MFN No. 025-92  
Docket No. STN 50-605  
EEN-9212

Subject: **GE Responses to the Additional Items Noted in the Draft SER for Chapter 7**

CONCERN - DSER Section: 7.1.3.2 , Page # 7-6 (DSER Summary Item # 4.a )

Figure 2.2.7a REACTOR PROTECTION SYSTEM

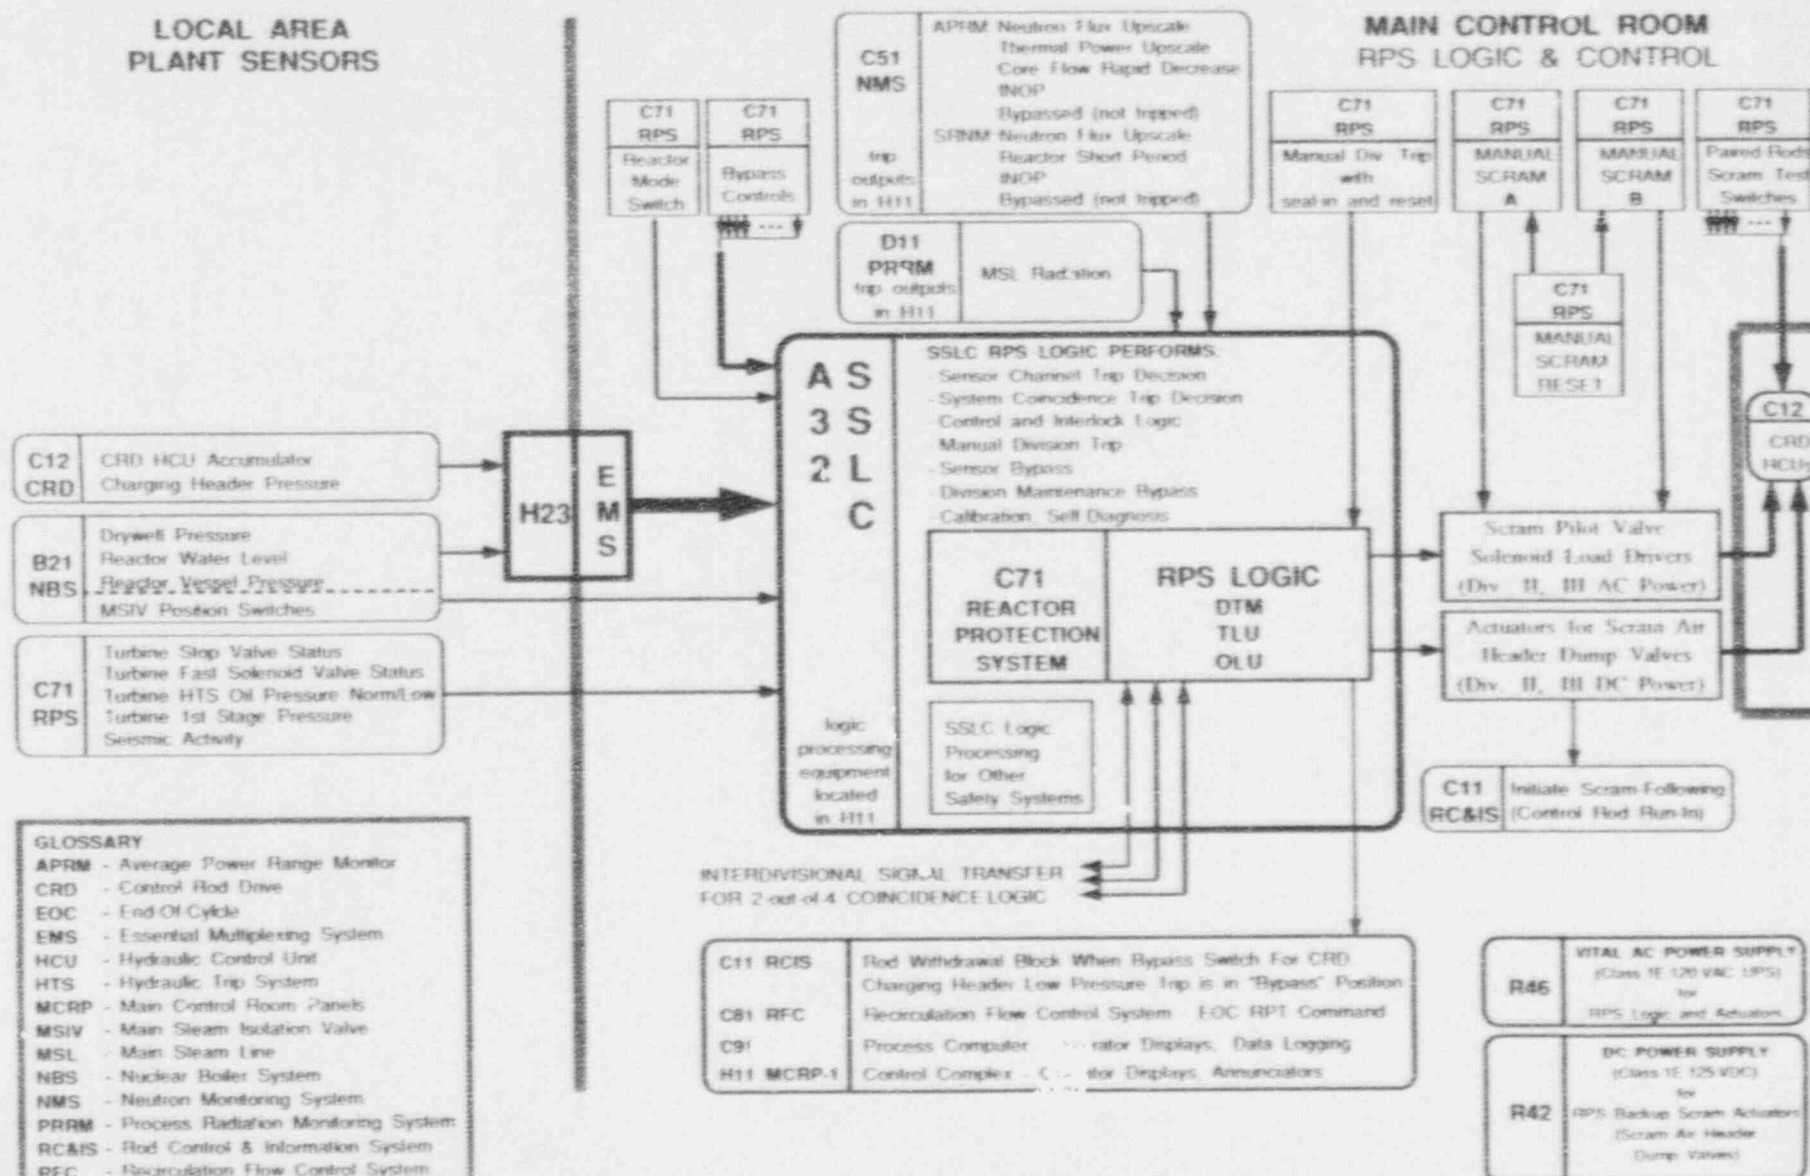
As shown in Figure 2.2.7a, the RPS interfaces with the neutron monitoring system (NMS), the process radiation monitoring (PRRM) system, the nuclear boiler system (NBS), the control rod drive (CRD) system, the rod control and information system (RC&IS), the recirculation flow control (RFC) system, the process computer system and with other plant systems and equipment. RPS components and equipment are separated or segregated from process control system sensors, circuits and functions such as to minimize control and protection system interactions. Any necessary interlocks from the RPS to control systems are through isolation devices.
